UNITED STATES PATENT AND TRADEMARK OFFICE

APPLICATION NO.	FILING DATE	FIRST NAMED INVENTOR	ATTORNEY DOCKET NO.	CONFIRMATION NO.
10/626,756	07/24/2003	Kevin Traynor	032674-200	1739

Office Action Summary	Application No.	Applicant(s)	
	10/626,756	TRAYNOR ET AL.	
	Examiner	Art Unit	
	Khanh Dang	2111

DETAILED ACTION

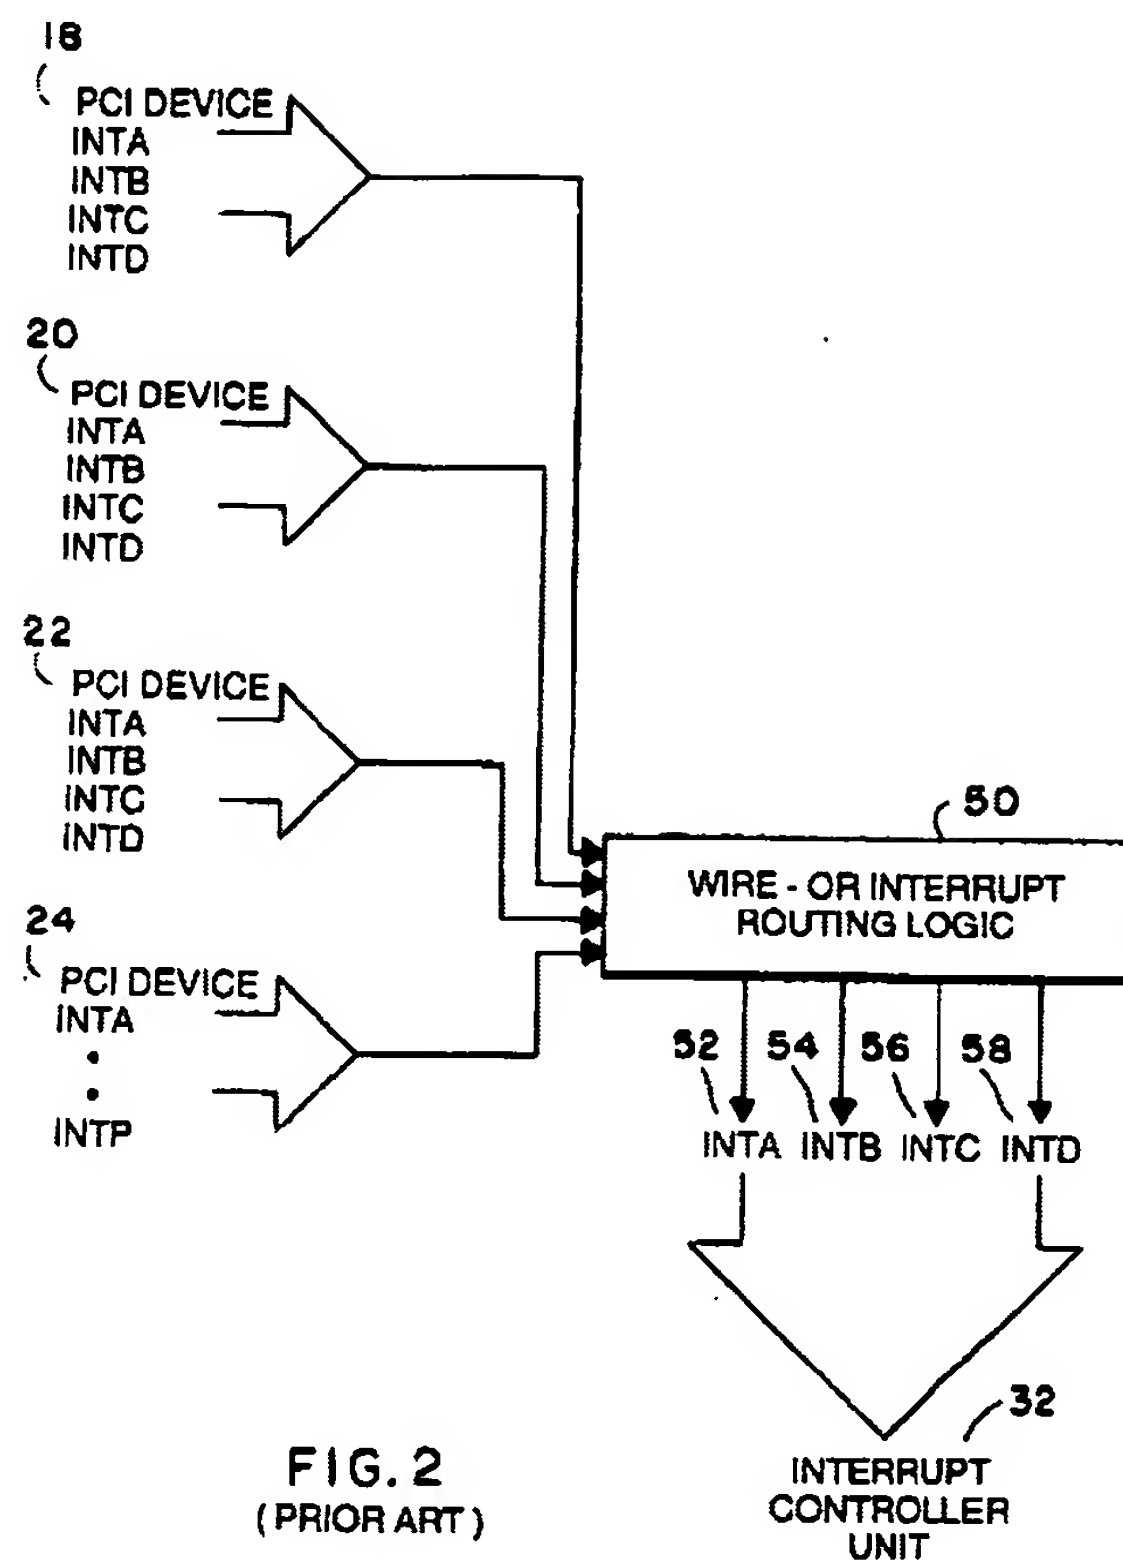
As broadly drafted, claims 1, 7, 21, and 23 do not define any structure/step that differs from Armstrong. As a matter of fact, by drafting claims 1, 7, 21, and 23, Applicants are attempting to claim the notoriously well-known interrupt sharing architecture defined by the PCI Local Bus Specification, as described in Fig. 2 of Armstrong, and specifically disclosed in column 1, lines 37-43 and column 2, lines 56-67.

With regard to 1, Armstrong discloses that method for sharing a plurality of interrupt inputs associated with a processor among a plurality of interrupt sources, comprising the steps of: mapping each of the plurality of interrupt sources to each of the plurality of interrupt inputs; and selectively enabling interrupt requests from each of the plurality of interrupt sources to one or more of the plurality of interrupt inputs (Armstrong discloses that, according to the PCI Local Bus Specification adopts a shared or wired-OR interrupt binding architecture. As shown in Fig. 2:

all PCI interrupt sources are wired-OR'ed in the wired-OR interrupt routing logic 50 to map into interrupt inputs INTA – INTD of the interrupt controller 32. As well-defined in computer architecture, the logic OR gate selectively enable an output based on values of the 2 inputs:

Thus, it is clear that the wired-OR serves as a decision making unit to selectively enable PCI interrupt requests from each of the plurality of PCI interrupt sources to one or more of the plurality of interrupt inputs INTA – INTD of the interrupt controller 32.

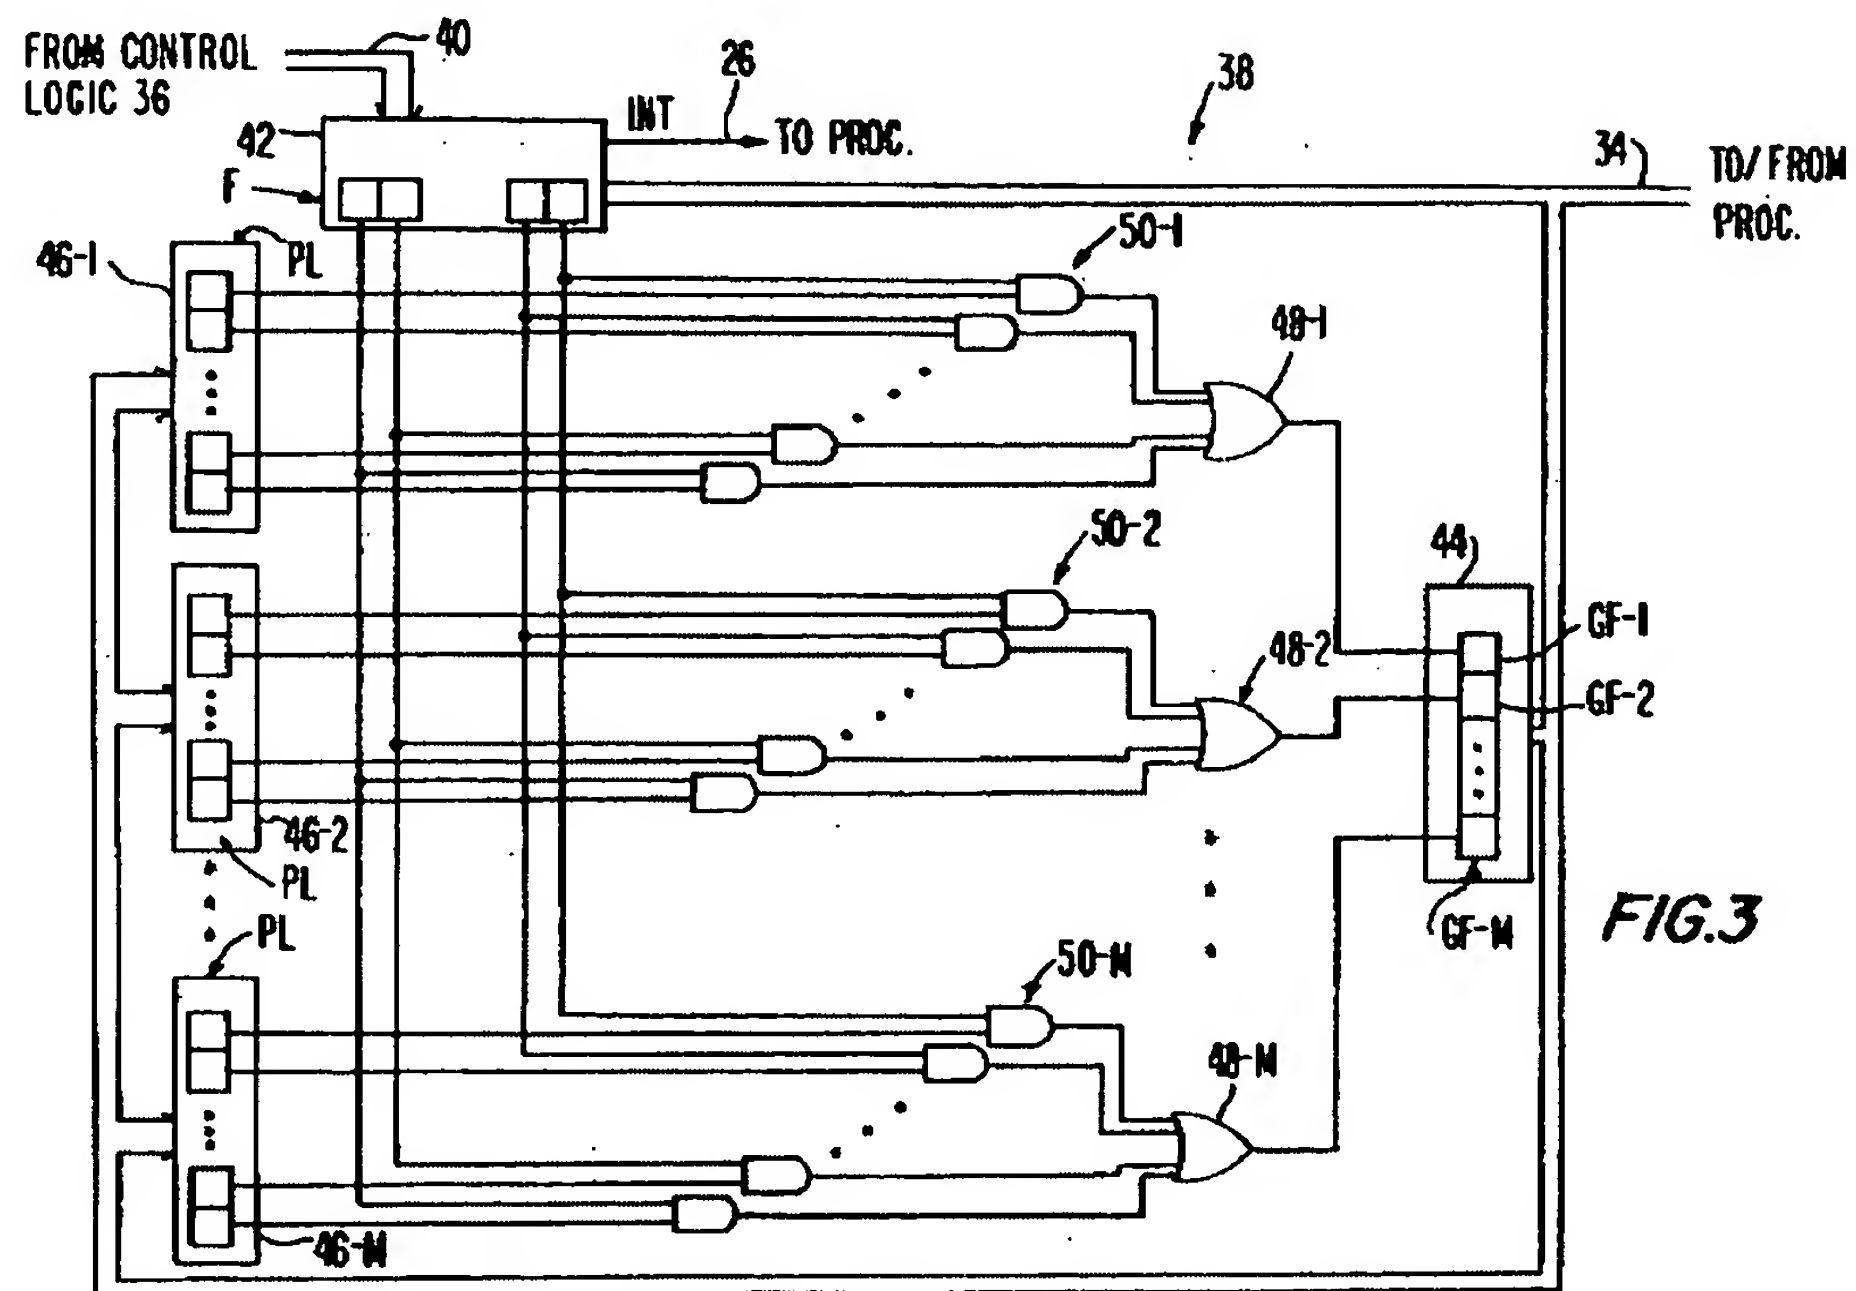
With regard to claim 1, Wach discloses a method for sharing a plurality of interrupt inputs associated with a processor among a plurality of interrupt sources, comprising the steps of: mapping each of the plurality of interrupt sources to each of the plurality of interrupt inputs; and selectively enabling interrupt requests from each of the plurality of interrupt sources to one or more of the plurality of interrupt inputs (Wach

discloses an interrupt architecture employing interrupt sharing, which is best illustrated in the following figure:

At the outset, in order to have a clear understanding of the following discussion, it is important to note that the interrupt requests can be generated from register 44 instead of register 42 (see column 11, lines 10-15). In addition, the term "group" used in Wash includes group that has only one interrupt resource (see column 11, lines 47-49).

As shown above and specifically described in column 4, line 63 to column 6, line 43; column 10, line 55 to column 11, line 48, the number of storage locations F in register 42 is equal to the number of interrupt sources, any one of which may cause the

transmission of the interrupt signal to processor 14. Also, the locations F correspond one-to-one to the interrupt sources. The plurality of interrupt resources are routed or mapped to a plurality of interrupt inputs represented by a plurality of locations GF; wherein the interrupt request signal generated when any one or more of the locations GF are set. Further, in Wash, a masking bit is used to enable or disable interrupt requests from each of a plurality of interrupt sources to one or more of the plurality of interrupt inputs. Specifically, when it is desired to mask a given one of the interrupt sources, processor 14 sends programming signals to the association registers 46 such that the value "0" is stored in the respective location PL corresponding to the interrupt source to be masked.

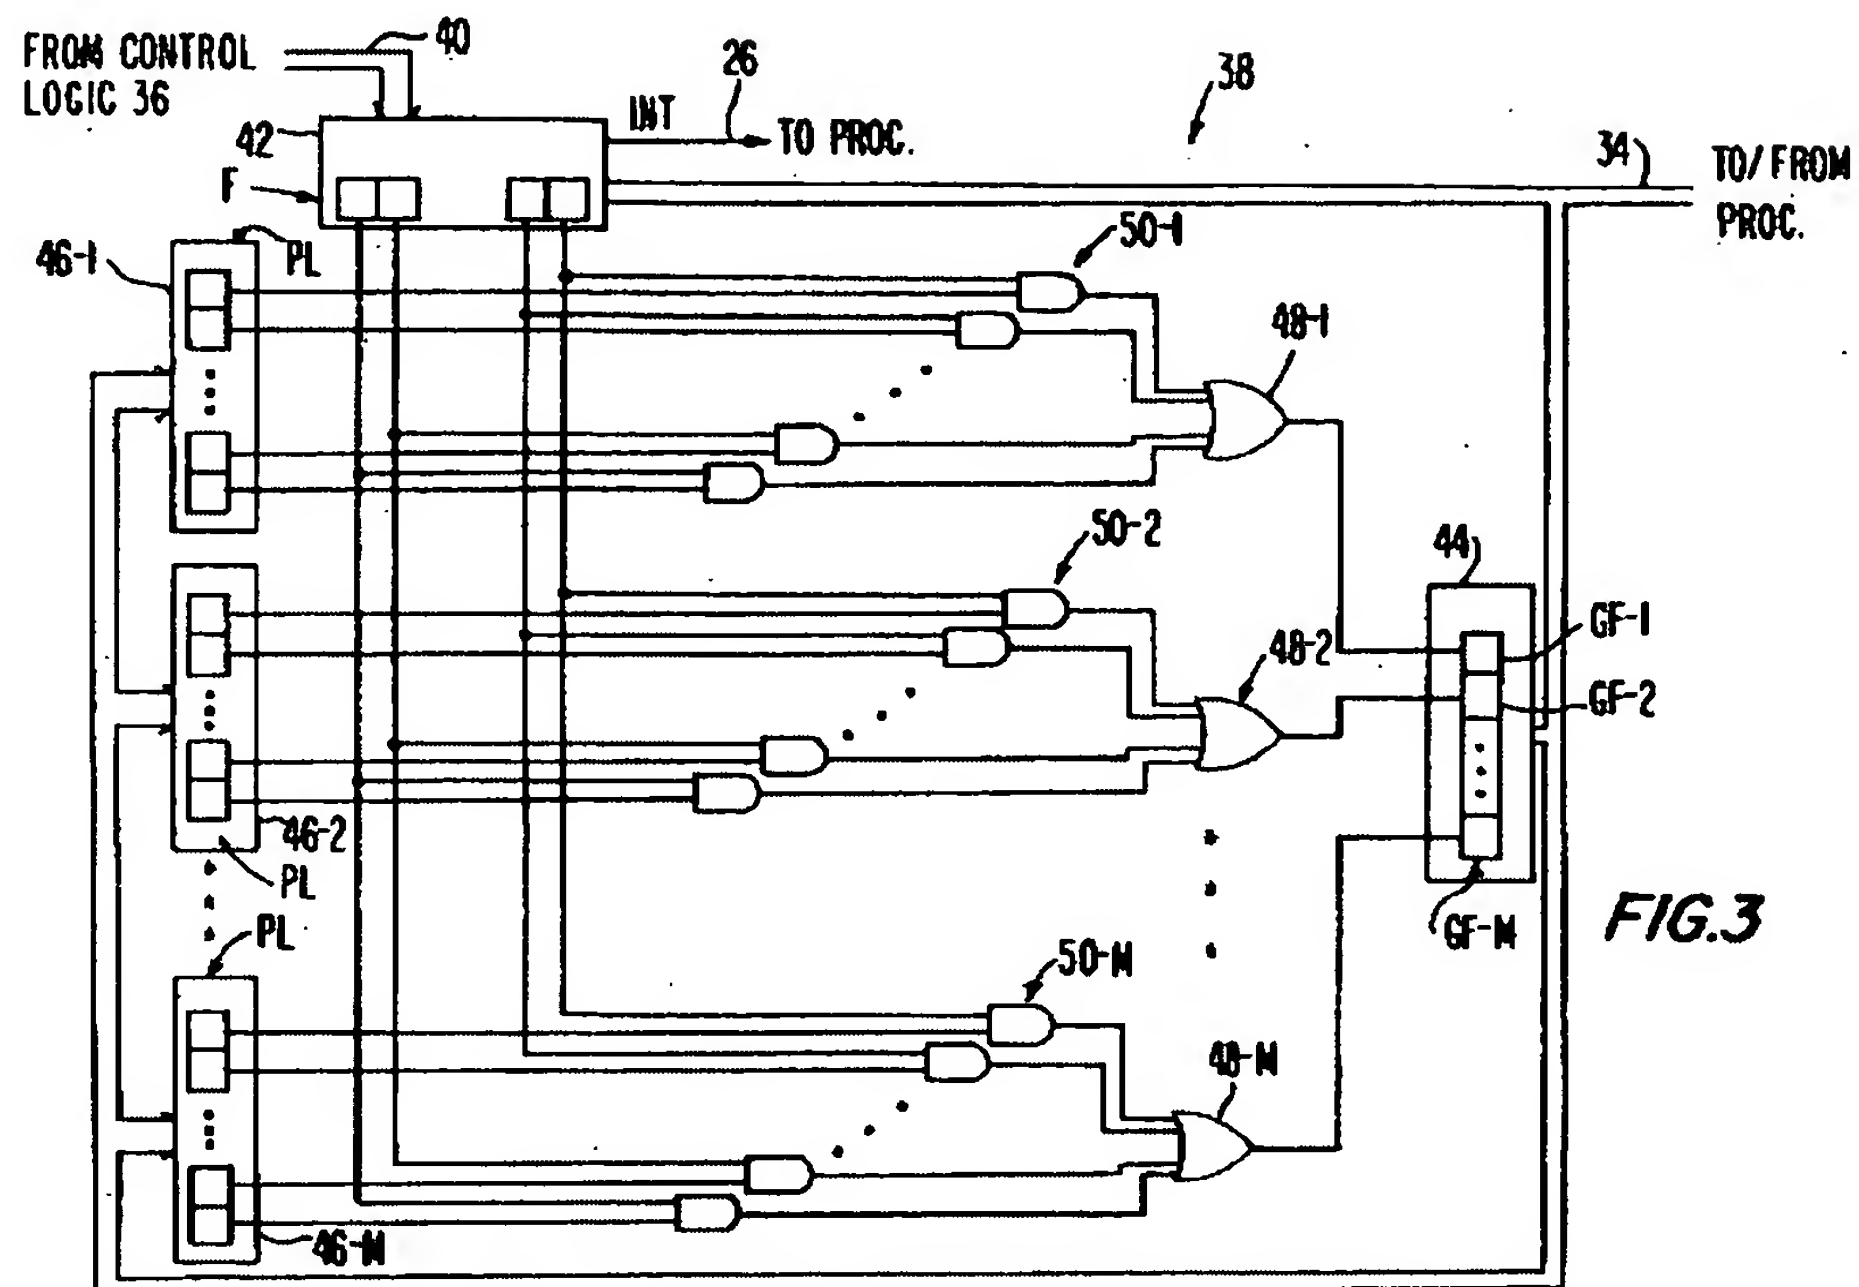
With regard to claim 13, as clearly shown in the figure above, the logic that selectively enables comprises, for each mapped interrupt source/interrupt input combination, a logical AND (50) for ANDing each interrupt source with a respective control bit value.

With regard to claim 14, Wash discloses a system for sharing a plurality of interrupt inputs associated with a processor among a plurality of interrupt sources (Wach discloses an interrupt architecture employing interrupt sharing, which is best illustrated in the following figure:

, comprising: for each of said plurality of interrupt inputs: a plurality of logical ANDs, each corresponding to an interrupt source, the corresponding interrupt source providing an interrupt request signal to the corresponding logical AND to interrupt the processor (a plurality of AND gates 50, each having an input to receive an interrupt request signal from an interrupt source to interrupt the processor; see also discussion above regarding claim 1); a plurality of control bits each corresponding to an interrupt source and each respectively providing a control bit value to the corresponding logical AND (a plurality of masking bits, each can be set in the location PL to provide a control value to the other input of AND gate 50; see also discussion regarding claim 1 above), wherein, based on the control bit value, a corresponding interrupt request signal is

provided at an output of the corresponding logical AND (based on the control bit value provided at one input of the AND gate, an interrupt request signal is provided at output of the AND gate 50; see also discussion above regarding claim 1); a logical OR arranged to indicate, to the interrupt input, the presence of a corresponding interrupt request signal from at least one output of the plurality of logical ANDs (as clearly discussed above regarding claim 1, the OR gate 48 is arranged to indicate the presence of a corresponding interrupt request signal from at least one output of the plurality of AND gates 50 to the interrupt input; see also discussion above regarding claim 1).

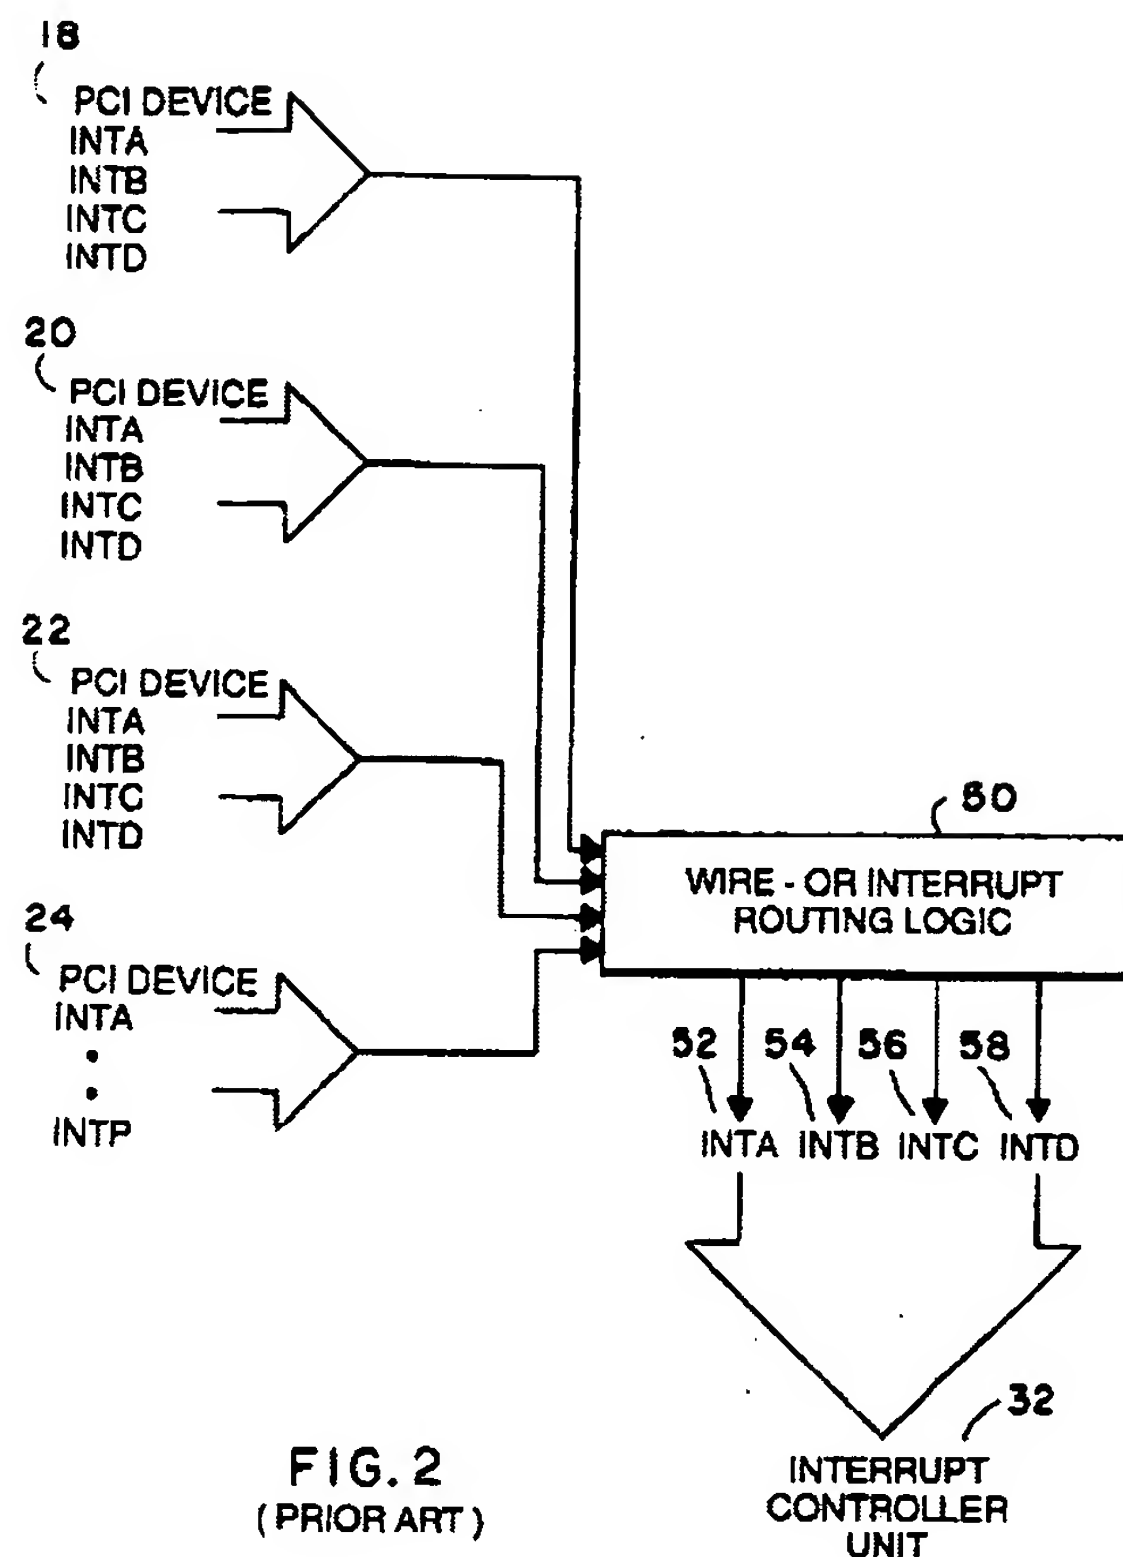
Armstrong discloses that, according to the PCI Local Bus Specification adopts a shared or wired-OR interrupt binding architecture. As shown in Fig. 2:

all PCI interrupt sources are wired-OR'ed in the wired-OR interrupt routing logic 50 to map into interrupt inputs INTA – INTD of the interrupt controller 32. As well-defined in computer architecture, the logic OR gate selectively enable an output based on values of the 2 inputs:

Thus, it is clear that the wired-OR serves as a decision making unit to selectively enable PCI interrupt requests from each of the plurality of PCI interrupt sources to one or more of the plurality of interrupt inputs INTA – INTD of the interrupt controller 32.

Therefore, contrary to Applicants' argument, the interrupt sources are the PCI devices 18, 20, 22, and 24. It is clear that interrupt sources generate interrupt requests, or in other words, interrupt requests are originated/generated from interrupt sources. It is also clear from the rejection above that each of the interrupt sources (each of PCI devices 18, 20, 22, and 24) is mapped into each of a plurality of interrupt inputs 52, 54, 56, and 58, inputted to the interrupt controller unit 32. In addition, it is also clear from the above rejection that interrupt requests INTA, INTB, INTC, INTD, INTN are originated/generated from/by each of a plurality of interrupt sources 18, 20, 22, and 24.
